**PLANNING COMMISSION
STAFF REPORT**

June 20, 2019

AGENDA ITEM: Planning File No. 059-19-MAJ: A public hearing of the Administrative Site Plan Application for changes to the appearance of the Baymont Hotel building, located at 1202 North Summit Boulevard/Lot 2A, Block A, Discovery Interchange West Subdivision. Applicant: 4U2 Relax Inc., represented by CTA Architects Engineers

Proposed South Façade

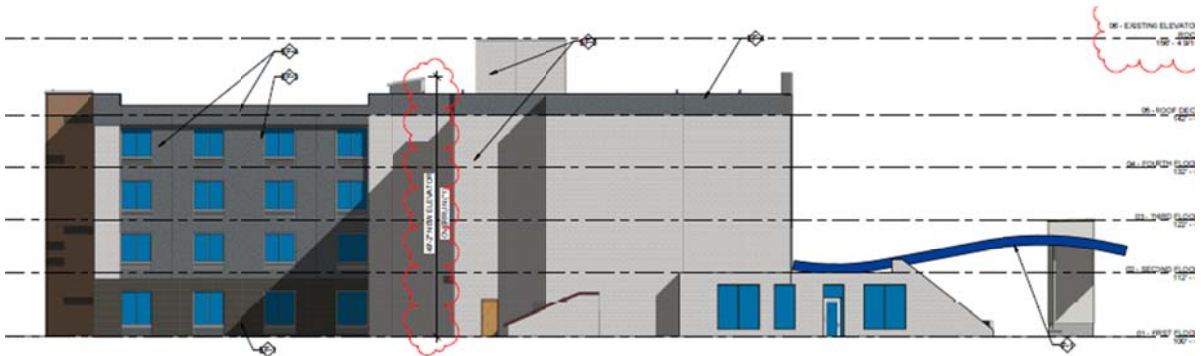
Below are images comparing the existing structure with proposed elevations. Planning Commission should note the changes to colors, materials, windows, and porte cochere.
